The bid solicitation is amended as follows

QUESTIONS

Photos of the hatches

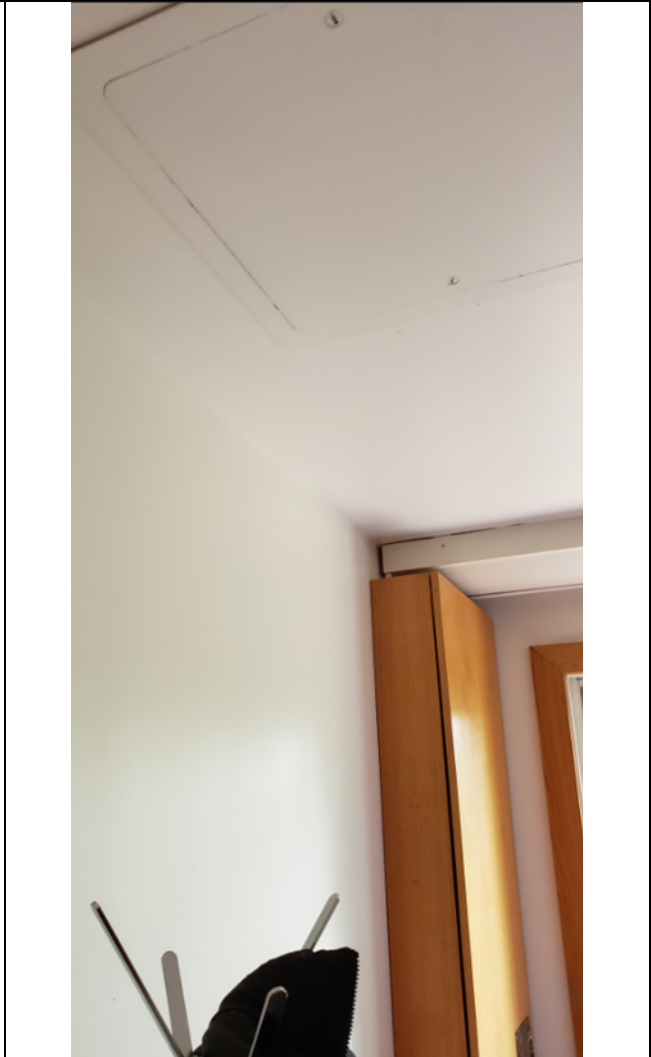
Q3: Can you please provide photos of the interior access as well as photos of the attic space?

A3: See below pages
